Product Change Notification: SYST-22EELM397

PIC18F06/16Q41 Silicon Errata and Data Sheet Clarifications

Added silicon errata issue 1.10.1.

1.5.1. UART TXDE Signal May Go Low Before the STOP Bit Has Been Entirely Transmitted

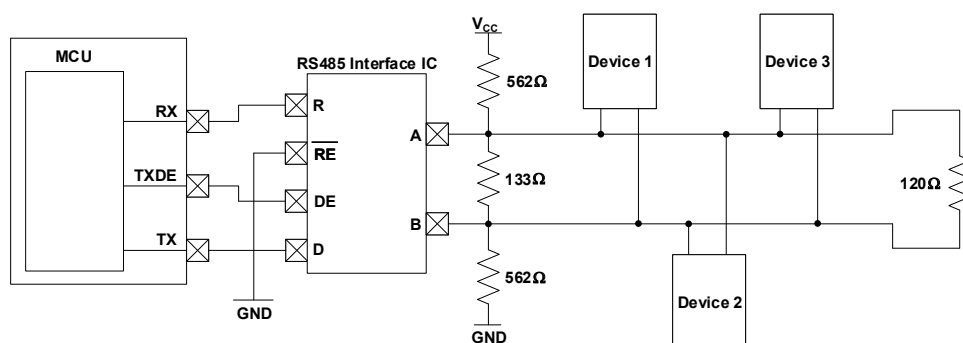
The UART Transmit Drive Enable (TXDE) signal could potentially transition into a low state before the UART Stop bit has been entirely transmitted due to the effects of parasitic capacitance on the TX line. In some applications, this could result in communication being prematurely terminated due to the TXDE signal going low before the STOP bit has had enough time to settle.

To ensure that the Stop bit settles into its final logic state before the TXDE signal transitions low, a biasing circuit can be implemented. A biasing circuit allows the TX line to either be driven high or low, rather than being left in a floating tri-state mode, where prolonged rise or fall times could lead to communication being disrupted. This bias circuit must only be implemented on one end of the serial bus, and a termination resistor must be used on the other end. The figure below shows an example of a bias circuit that can be used to achieve this.

Please note that the resistor values used in this circuit are recommendations and that the actual resistor values required may vary based on the application.
